PUBLIC UTILITIES COMMISSION

Re: Information Request for the Southern California Edison's Application for a Certificate of Public Convenience and Necessity for the Riverside Transmission and Reliability Project, CPUC Application No. A.15-04-013

Figure 1 RTRP Layout, Harmony Trails Vicinity

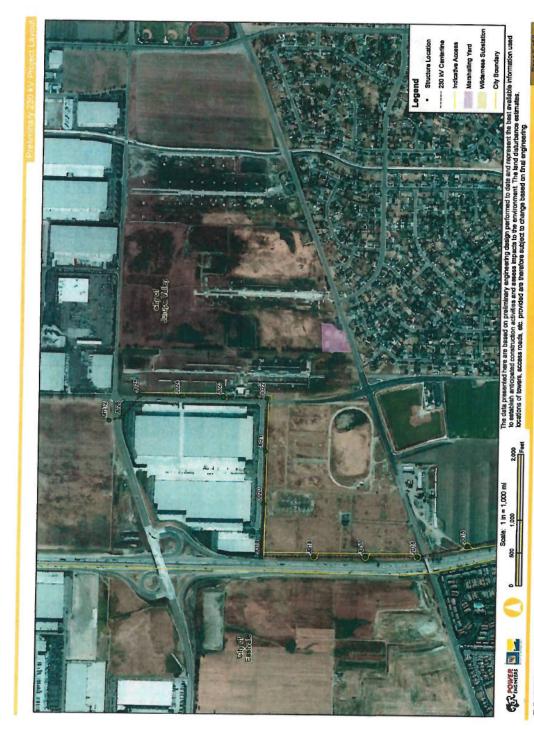
As part of the CPUC's CEQA review, we require additional information in order to better understand the current baseline condition and to more accurately portray the potential effects on the Harmony Trails site layout. Specifically, it appears that proposed 100-foot RTRP right-of-way (ROW) would be in conflict with 36 parcels of Tentative Tract Map No. 36692 (per Figures 1 and 2 below). The RTRP ROW includes three lattice steel structures (numbers JD23, JD24 and JD25) within the Harmony Trails site. To better understand this potential impact, the CPUC requests the following additional information:

- A conceptual site development layout depicting how the Harmony Trails site would be configured if the RTRP Project were built as depicted by SCE (see Figure 1). Please confirm the number of lots in the development that would be lost as a result of the proposed ROW.
- A summary of square footage of multi-purpose trail, pedestrian and landscaped parkway lost or gained in relationship to the proposed SCE ROW design as depicted in the Tentative Tract Map No. 36692 (see Figure 2).
- 3. Details on the construction phasing and build-out schedule for the Harmony Trails project.
